CITY PLAN COMMISSION**THURSDAY, March 26, 2026****FILE NUMBER:** PLAT-26-000072**SENIOR PLANNER:** Hema Sharma**LOCATION:** St. Augustine Road, south of Teagarden Road**DATE FILED:** March 2, 2026**ZONING:** R-5(A), R-7.5(A)**CITY COUNCIL DISTRICT:** 8**SIZE OF REQUEST:** 28.33-acres**APPLICANT/OWNER:** S.I. Abed, Mohammed Amirul Islam

REQUEST: An application to create 198-lots Small Lots SB15 Development ranging in size from 3,000 square feet to 4,000 square feet, 10 common areas and one detention and retention pond area from 28.33-acre tract of land in City Blocks 8503 and 8769 on property located on St. Augustine Road, south of Teagarden Road.

PRELIMINARY PLAT
BERWICK HOUSE ADDITION 1
SMALL LOTS SB15 DEVELOPMENT

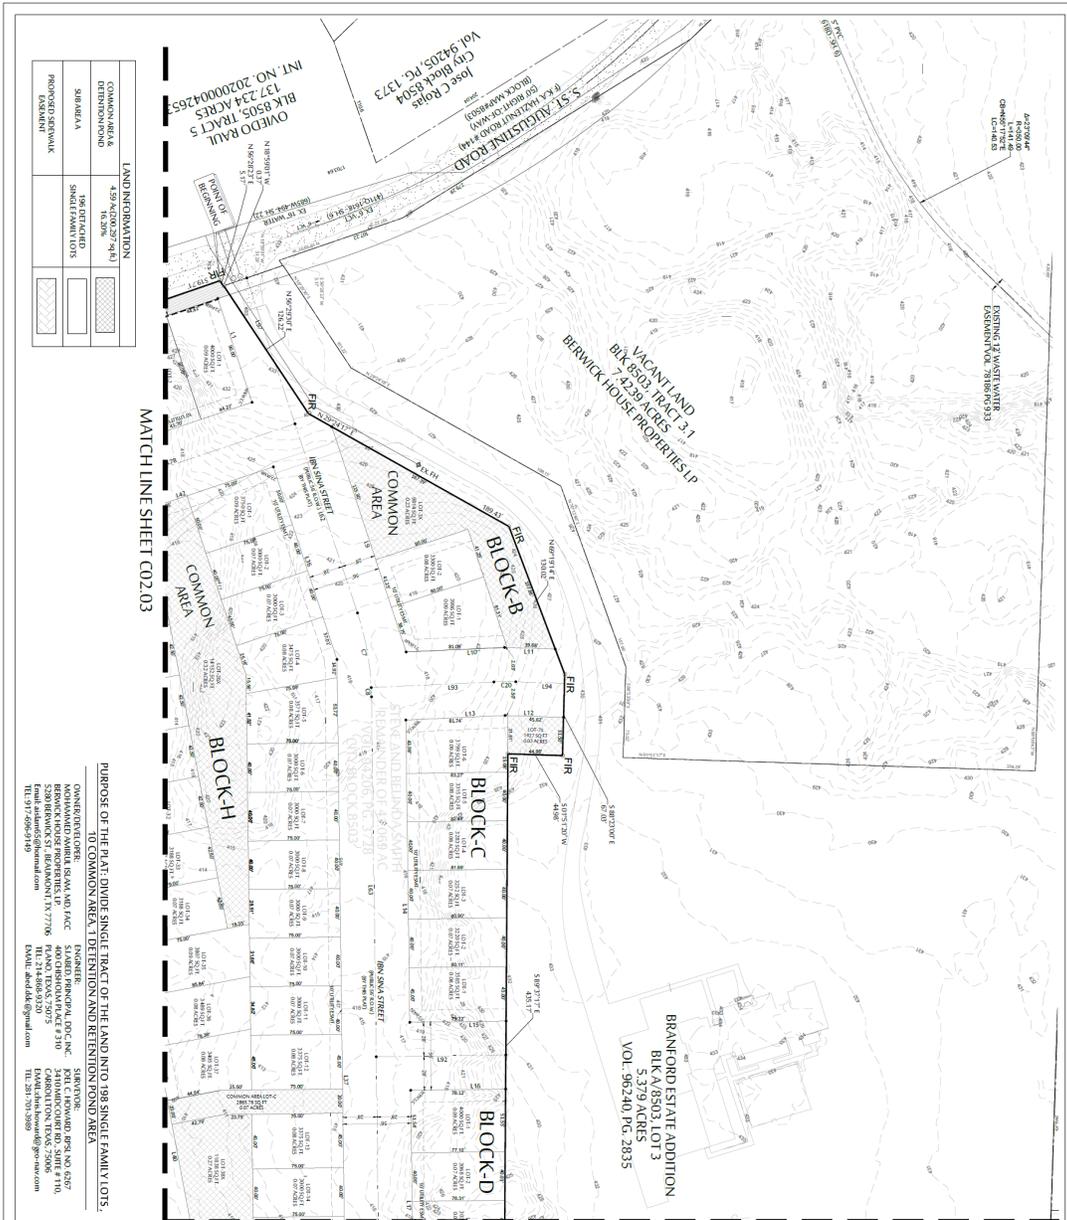
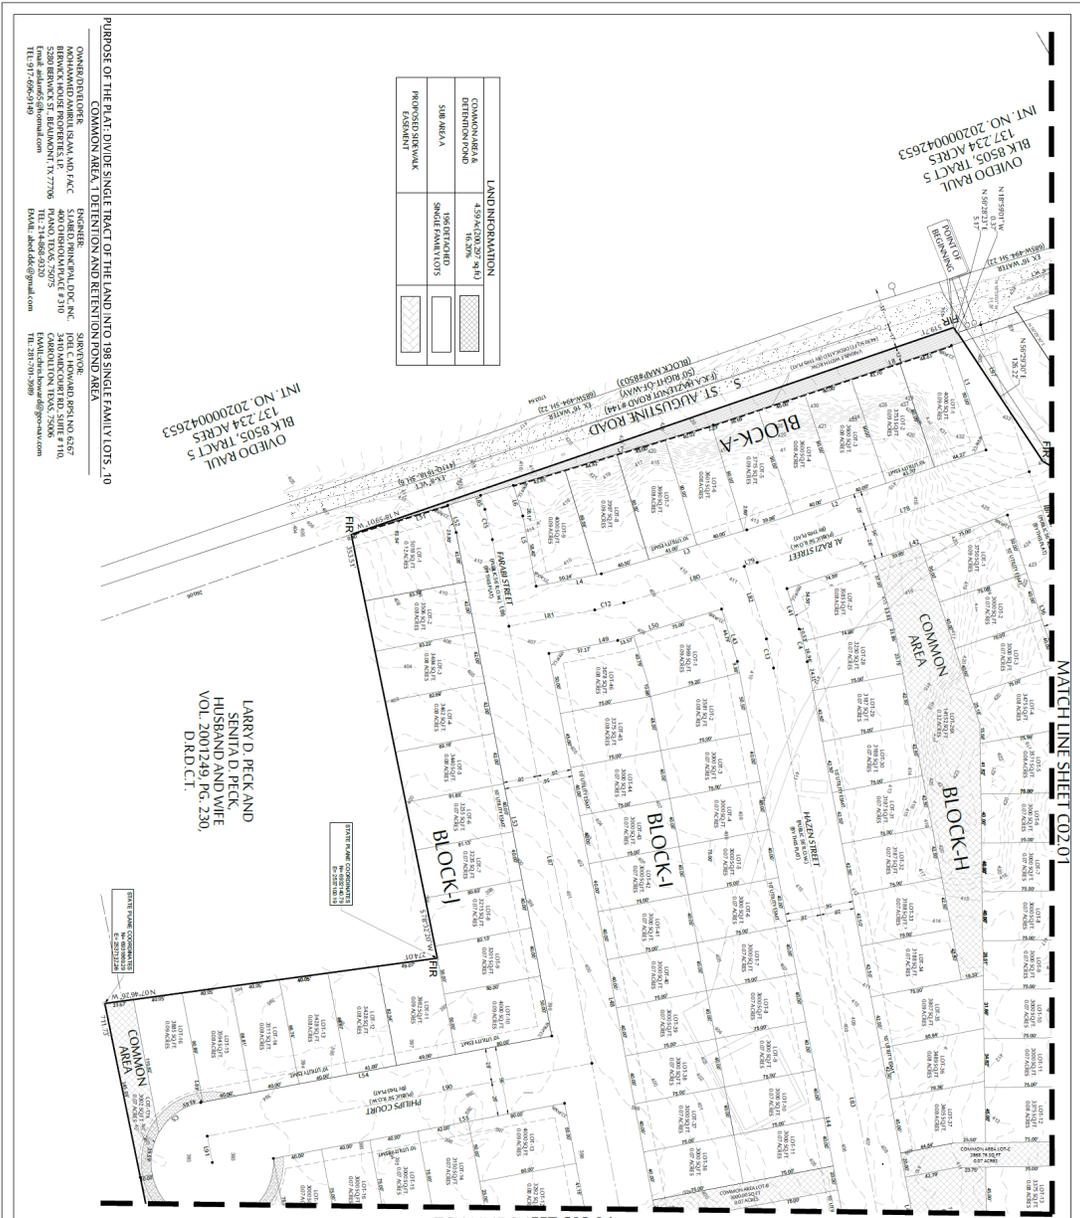
15. On the final plat, dedicate 30 feet of right-of-way (via fee simple) from the established center line of St. Augustine Road. *Section 51A 8.602(c)*

16. On the final plat, dedicate 28 feet of right-of-way (via fee simple or street easement) from the established centerline of all proposed Local Streets. *Sections 51A-8.602(c), 51A-8.604(c) and 51A-8.611(c).*

21. Prior to final plat, submit a completed final plat checklist and all supporting documents.
22. On the final plat, show how all adjoining right-of-way was created. *Section 51A-8.403(a)(1)(A)(xxii).*
23. On the final plat, show recording information on all existing easements within 150 feet of the property.
24. On the final plat, remove General Note number three (3.).
25. Show abstract line location.

29. On the final plat, change "Long Island Dr" to "Long Island Drive". Section 51A-8.403(a)(1)(A)(xii).
30. On the final plat, change "S. St Augustine Road (FKA Hazelnut Road #144)" to "St. Augustine Road (AKA St. Augustine Drive FKA Hazelnut Road FKA County Road No. 144)". Section 51A-8.403(a)(1)(A)(xii).
31. On the final plat, identify the property as Blk 1/8503 Lots 1-2, Common Area A; Blk 2/8503 Lots 1-6, Common Area B; Blk 3/8503 Lots 1-4, Common Area E; Blk 4/8503 Lots 1-34, Common Area F; Blk 5/8503 Lots 1-14; Blk 6/8503 Lots 1-14; Blk 7/8503 Lots 1-36, Common Areas C & D; Blk 8/8503 Lots 1-46, Common Area J; Blk 9/8503 Lots 1-9; Blk 10/8503 Lots 1-16, Common Area G; Blk 11/8503 Lots 1-17, Common Area H & I.
